**B-CLEAN LAUNDRY
AMENDED SP**

B-Clean Laundry-Amended S.P.
Walsh Road (Cuomo)

**SUBJECT: B-CLEAN SITE PLAN
NWPB NO. 99-5**

TYPICAL H.C. Parking Details

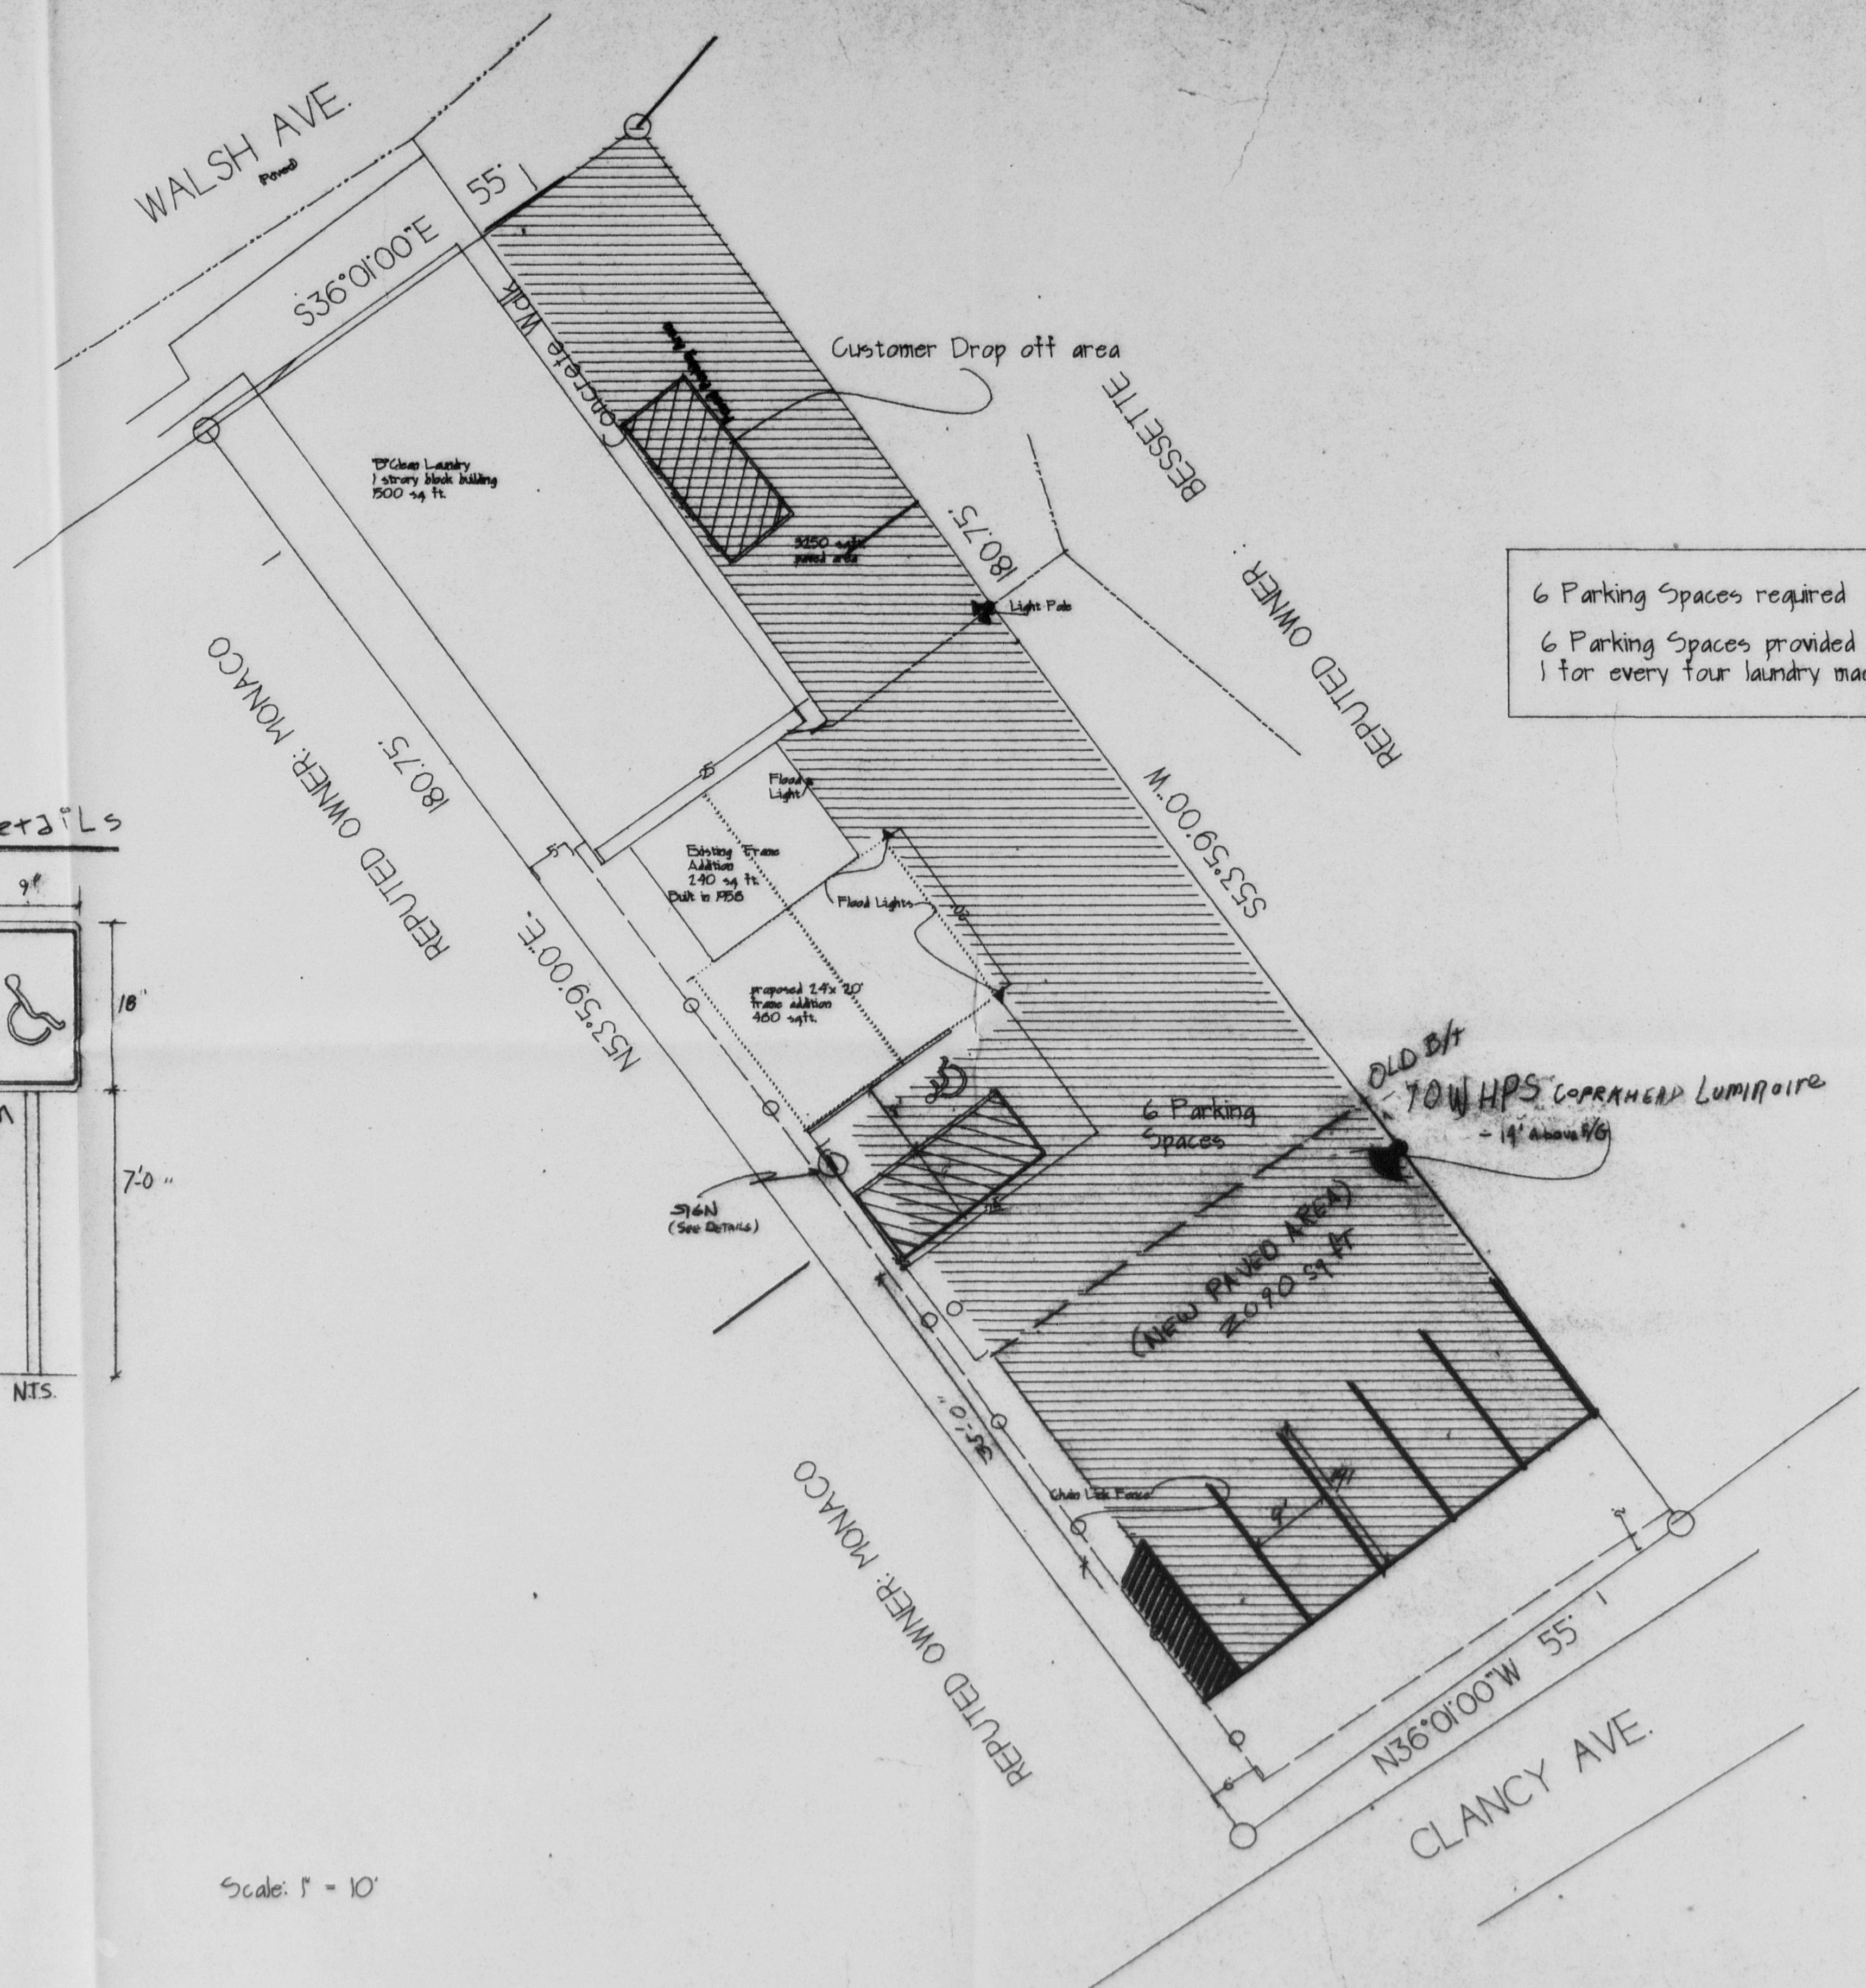
1. In my comments to the Planning Board dated 14 April 1999 I noted that the handicapped sign detail was in contradiction to the State Code requirements. The required correction **has not** been accomplished.
2. The plan notes a 300W HPS Flood at 14' mounting height. The submitted information indicates a 70W HPS Cobrahead Luminaire. It is my understanding from the Planning Board discussions that the Luminaire type is the acceptable type. I would suggest that the plan be corrected to match this selection.
3. The balance of the corrections requested on the plans have been successfully accomplished.
4. Regarding the cost estimate, I have made some corrections and the revised amount is noted on the attached sheet.

MR. PETRO: Mark, handicapped parking spot, I see he has 24 foot, shows 24 foot dimension there which is the building but he's not showing the handicapped, does he have a detail somewhere?

MR. PETRO: It's 18, not 19 there, Paul, do you see that, the length of the handicapped parking spot, you have it down on your detail, you need to correct that to 19 feet.

MR. PETRO: Crosshatch and the parking spot itself looks like the backout area now is sufficient as you moved all the parking down, the parking spots at the rear of the lot are correct, 9 x 20, I think 9 x 19 is required.

MR. BABCOCK: Parking spots in the rear, Paul, 9' x 18 should be 9 x 19.
